INDESIT company

Model type:
LBE12X

Commercial code:
F026961

7.Technical documentation cover shows model name and its commercial codes

n1040241: Indivisible timer knob and push-push mec

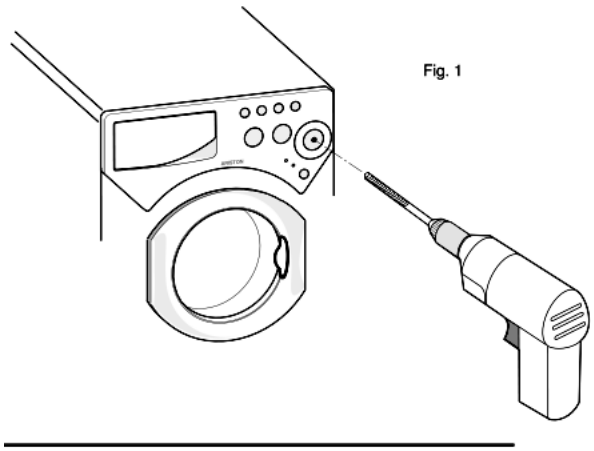
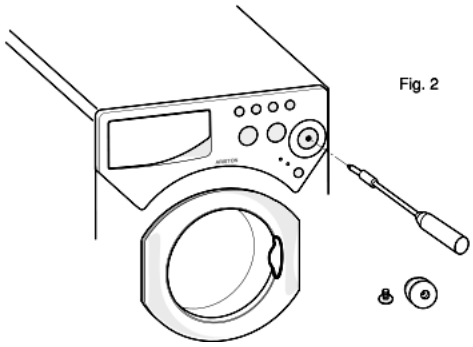
From serial number 20305.0001, the component knob / selector code 084812 is provided with internal flaps, which ensure a perfect assembly of the knob and push-push mechanism on the built-in washing machines. This prevents the knob from coming off when the plastic material becomes soft due to temperature increasing inside the appliance during the drying phase.

To remove the selector knob, proceed exclusively as follows:
1) Using a drill with a 12 mm bit, drill a hole in the centre of the knob (see fig. 1).
2) Using a cross screwdriver, loosen the screw that secures the knob to the selector (see fig. 2);
3) Extract the knob with push-push mechanism from the selector (see fig.2) .

Fit the new knob after fixing with the screw the push-push mechanism (recovered) to the selector shaft.
In the event that the old push-push mechanism cannot be reused, use the kit code 087814 that comprises the following items:

Code 084816 - Push-push mechanism;
Code 087815 - Timer screw 1/2 T4,2X12.7;
Code 047922 - Compression spring;
Code 084812 - Component knob / timer.

Code 087814 replaces the timer knob kit 084815 used on the Built-in Washing Machines, which is managed until stocks run out and has a different screw code 056511.

FIG. 1

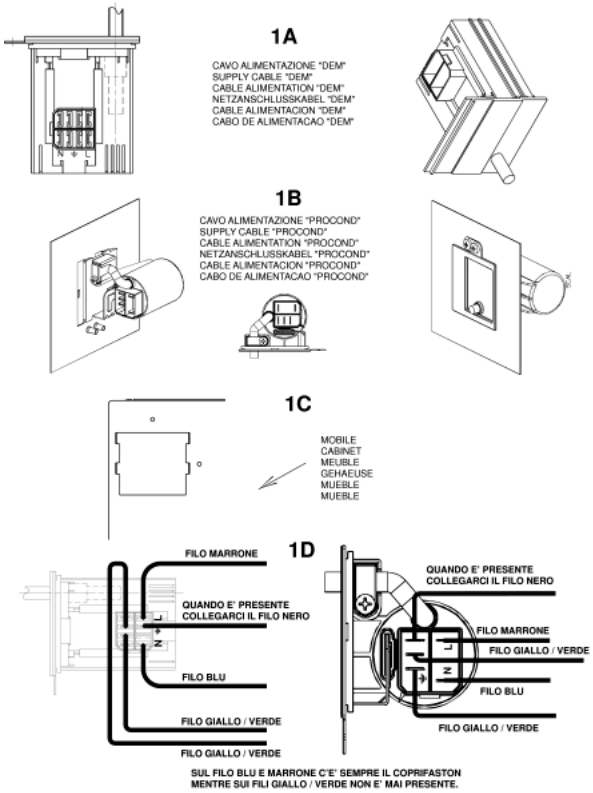
All appliances produced in the Comunanza (from serial no. 21008.0001), Teverola (from serial no. 21111.0001) and Brembate (from serial no. 21119.0001) factories have been equipped with power supply cables with integrally moulded filter (see fig.1 - 1A and 1B) and new units having a specific opening at the back for fixing the new cables (see fig. 1 - 1C).
The new units, together with the new cables, can be used in place of the premodification ones, by connecting the wiring to the cable, as shown in figure 1 - 1D.
The codes of the new units and of those replaced (ESI - table n1040276fig02), which will be managed until stocks run out, are given below.

IMPORTANT: the fixing / continuity screw is a specific self-scraping screw (code 092348) that ensures earth continuity between the filter and the unit. The same screw must be refitted in order to guarantee machine conformity.

The premodification wirings, are also managed for modified products by making the connection to the terminal block of the new cable as shown in fig. 1 - 1D.
The wiring diagrams given in the Documentation remain unchanged.

n1040282: New drainage OKO system.

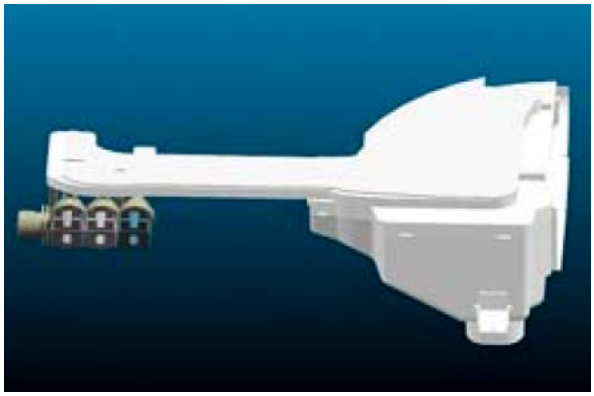
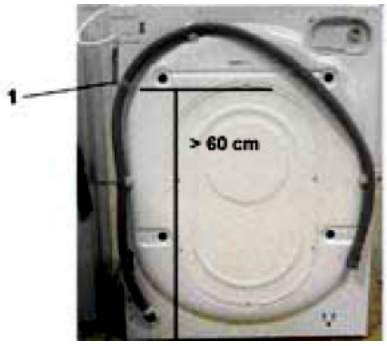
From serial number 21219.0001, the new "OKO" drainage system has been introduced on the washing machines produced in the Comunanza factory.
The last two numbers of the Industrial Code (located on the rating plate) of the models relevant to this note will be 30 (e.g. 80233560130 - see Appendix A)

- EEPROM (the OKO system requires a new setting of load timing parameters). THE NEW EEPROMS REPLACE ALL THE ONES CODED PREVIOUSLY.
- BOWL (hopper tube hole shifted forwards);
- DETERGENT LOADING TUBE (see fig. 1);
- PRESSURE SWITCH (changed levels);
- OKO PUMP BOWL BLOWER + BALL (see fig. 2A, 2B and 2C);
- CONDUCTIVITY SENSOR (if provided, it is shorter than the premodification item);
- DRAIN PUMP (without detergent collecting tube connection);
- HOPPER (shifted in front of detergent loading tube connection). Fig. 3A post-modification. Fig. 3B premodification);
- AIR TRAP (different shape);
- PRESSURE SWITCH TUBE (different length);
- DRAIN TUBE STOP (specific);

In particular, the OKO system consists of a spherical plastic component inserted in the tube that connects the bowl to the drain pump (see fig.2 A).
At the beginning of each wash cycle the washing machine fills water for 10 seconds and activates the drain pump for 2 seconds. In this way, the water level in the bowl is different from that in the drain tube; this difference increases the thrust of the ball upwards, closing the bowl-pump connection tube hermetically (see fig. 2D).
This system has the double advantage of:

1) separating the wash water and the water in the drain hose, thus saving energy during the heating phase;
2) and ensuring optimal use of all the detergent.
With the introduction of this new component, the detergent collecting tube is no longer required and the pump has one hole only to convey water from the tank.
For the correct operation of the OKO system, it is important that the drain hose of the washing machine remains fixed to the back of the unit with a plastic clamp (to this end, the clamp withstands a 25 kg load; see reference 1 in fig. 4); otherwise, the drain hose

must absolutely reach the height of the clamp. (minimum 60 cm.)

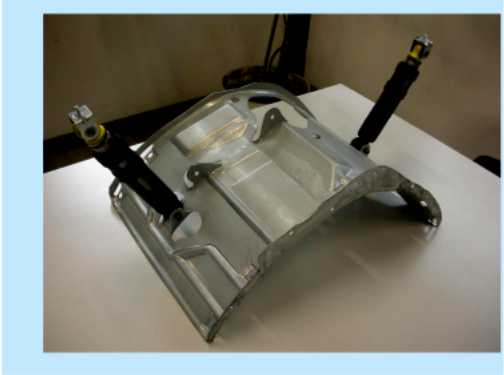
From serial no. 40427.0001, shock absorbers have been fixed to the tank unit cradle with two 11 mm pins code C00110163 (see fig. 01 and 02 enclosed) in place of the 8 mm screws code 093750 and relevant locking nuts code 030443, on all washing machines and dryers produced in the Comunanza factory.
The items affected by this modification are:

1) The cradles have the same Service code, as they can be used in place of the new ones after widening the shock absorber fixing holes to a diameter of 10 mm.
Code 093848 - Tank unit cradle 46 lt
Code 093878 - Tank unit cradle 40 lt.

2) The new shock absorbers, with fixing bushing having no s/steel spacer, are not managed as they are interchangeable with the premodified items (make sure they are CIMA type, as the managed items), fixed with M8 screws code 093750 and related locking nut code 030443 (see figs. 05 and 06).
Code 093884 - Shock absorber 80 N
Code 093885 - Shock absorber 100 N

To remove the shock absorber from the tank, first extract the pin with a few hammer taps (see fig.03) until it is aligned with the tank bracket and then pull it out with a pair of pliers (see fig. 04).
(To refit the shock absorber use a new pin. Insert the pin until the toroidal edge is aligned with the bracket.)

Fig . 001

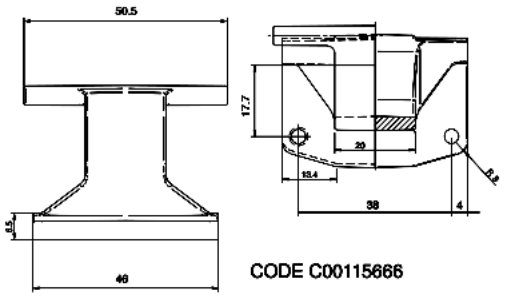
n1040349: Introduction of 150° Zamac hinge on Ariston 46 models.

(see Fig.001).
This modification has involved the introduction of the following items:

The premodified items are not interchangeable separately with the modified ones.
